### **Origination Form**

### Proposed Revisions to a Standard Plans Index

Originator:	Caldwell, Carey Allie	Index Number:	700-101
Date:	6/30/2025	Sheet Number(s):	1
E-mail:	Carey.Caldwell@dot.state.fl.us	Index Title:	Typical sections for placement of single and multi-column signs

**NEW SHEET 1**

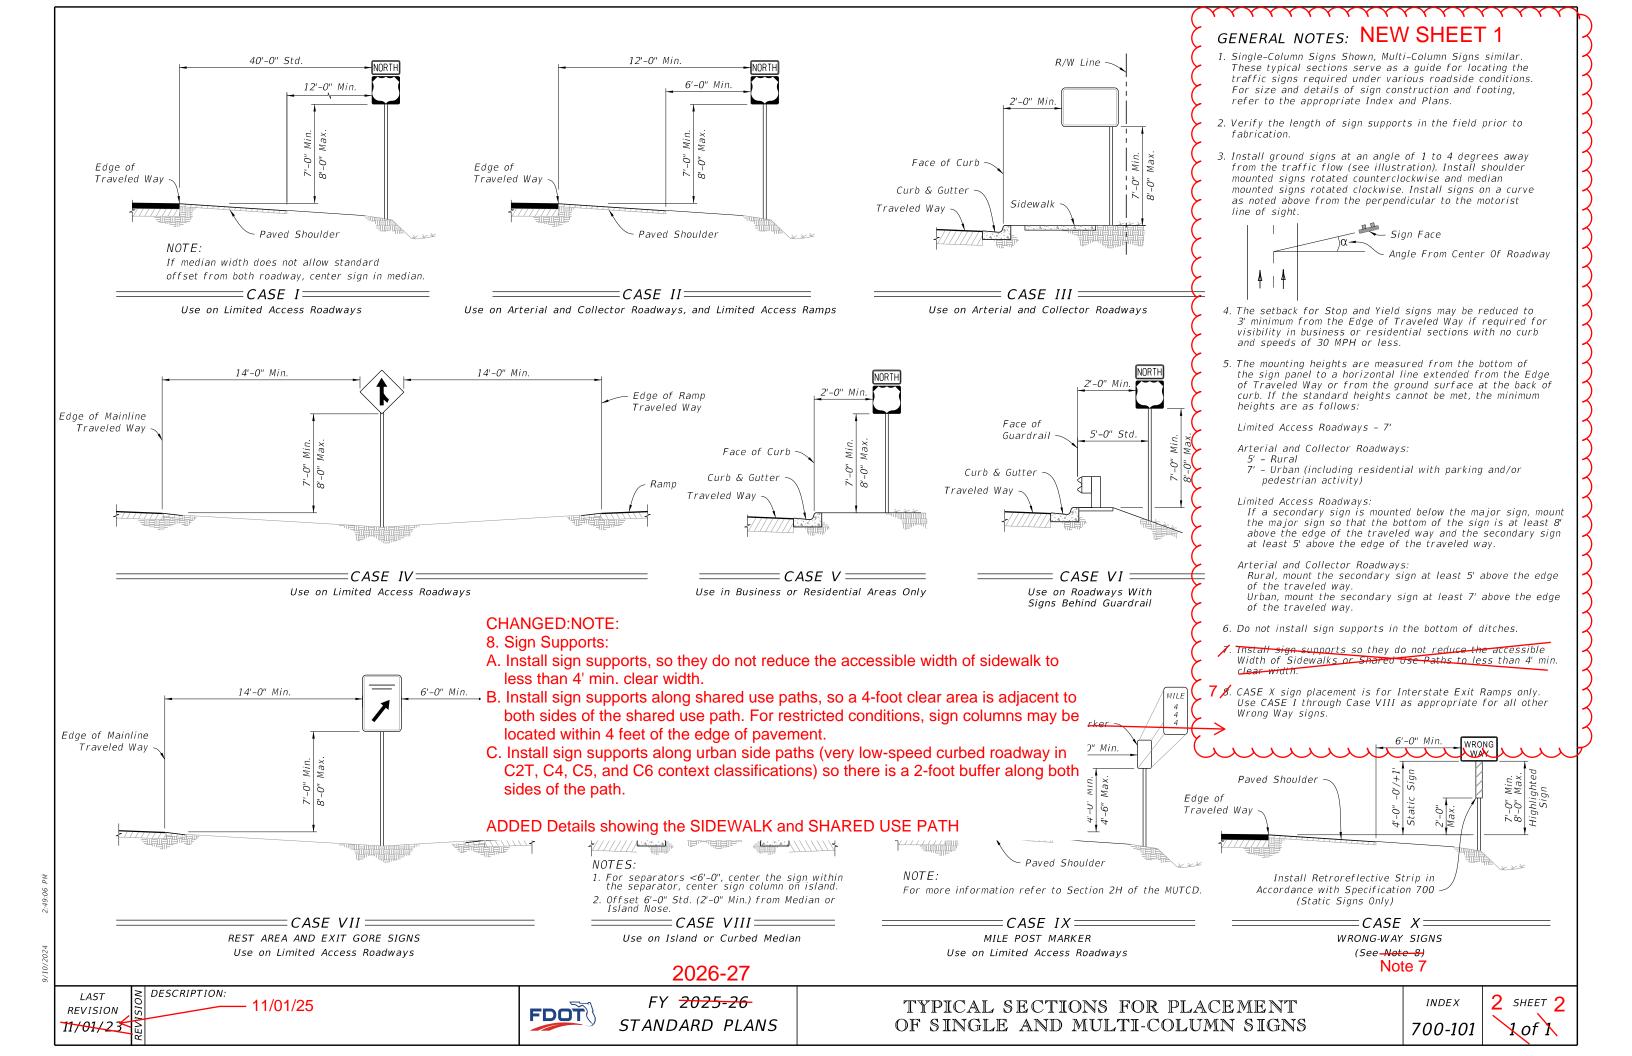
Sheet 1: Created General Notes Sheet; Deleted Note 7; Added New Note 8 "Sign Supports:

- a. Install sign supports so they do not reduce the accessible width of sidewalk to less than 4' min. clear width.
- b. Install sign supports along shared use paths, so a 4-foot clear area is adjacent to both sides of the shared use path.
- c. Install sign supports along urban side paths so there is a 2-foot buffer along both sides of the path." ADDED Details showing the SIDEWALK, SHARED USE PATH, and URBAN SIDE PATH

Note 7 does not provide enough information for placing signs along a shared use path or urban side path. Additional language is needed inform proper placement of sign columns along shared use and urban side paths.

- 6. Do not install sign supports in the bottom of ditches.
- 7. CASE X sign placement is for Interstate Exit Ramps only. Use CASE I through Case VIII as appropriate for all other Wrong Way signs.
- 8. Sign Supports:
- A. Install sign supports, so they do not reduce the accessible width of sidewalk to less than 4' min. clear width.
- B. Install sign supports along shared use paths, so a 4-foot clear area is adjacent to both sides of the shared use path.
- C. Install sign supports along urban side paths so there is a 2-foot buffer along both sides of the path.
